Informal document GRB-63-01
(63rd GRB, 16-18 February 2016,
agenda item 2)

Proposal for Supplement 5 to Regulation No. 28

The text reproduced below was prepared by the expert from the Russian Federation in addition to document ECE/TRANS/WP.29/GRB/2016/2. It contains a number of comments to clarify the modifications made to the original proposal in document ECE/TRANS/WP.29/GRB/2015/7. The proposed amendments to the current Regulation are marked in bold for new or strikethrough for deleted characters.

Microphone positions for measurements acoustics parameters of audible warning devices

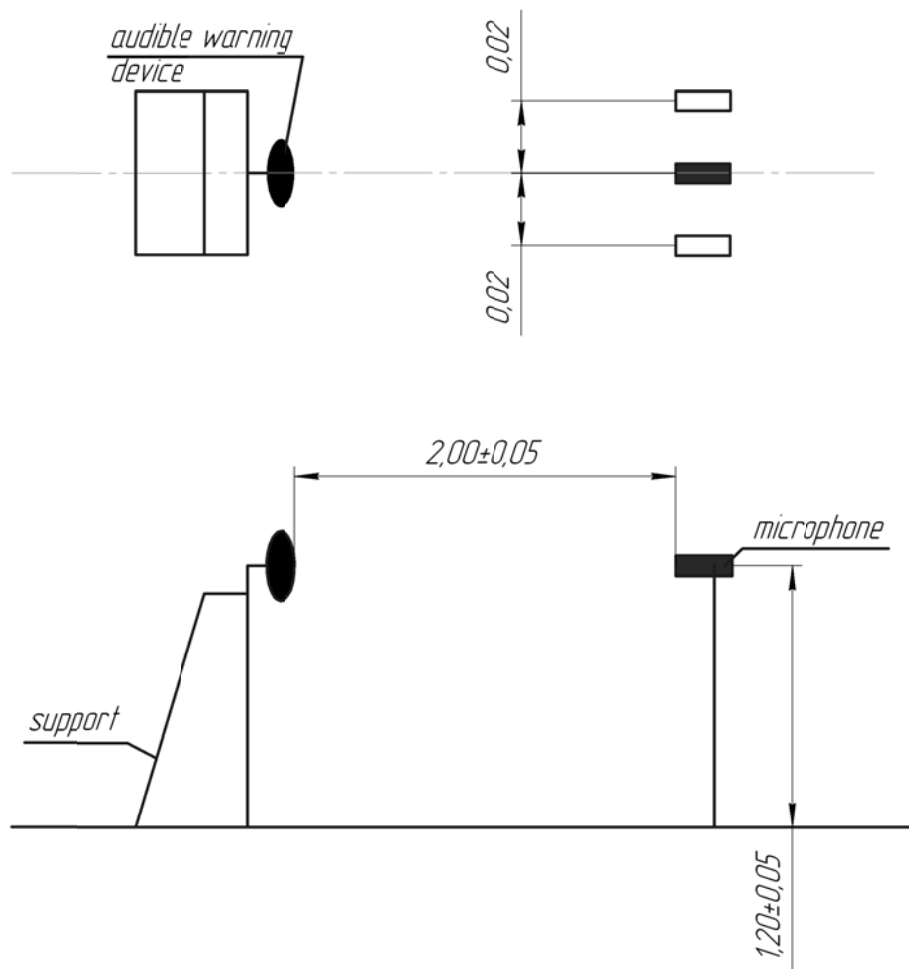
The microphone shall be so placed that its diaphragm is at a distance of 2.00 ± 0.01 0.05 m from the plane of the sound outlet of the device. **The microphone must be positioned facing the front surface emitting sound of the warning device in the direction in which the maximum sound level can be measured. See figure in Annex 3.**

1. Sections 7, 10, 15, 19 reflect the change of headers. A new section 18 is added. New Annexes 4 and 5 are added with graphical information.

Microphone positions for measurements audible signals of motor vehicles

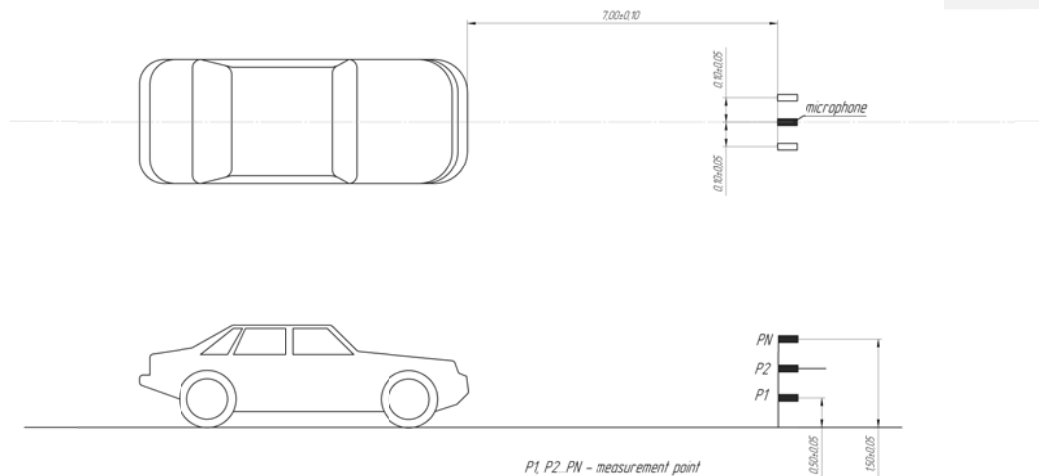
Comment [A25]: The text is based on OICA proposal as in GRB- OICA GRB-62-21-Rev.1. It is proposed at first to find a height, where the maximum sound pressure level was achieved. On the second stage the sound pressure level shall be measured at that fixed height.
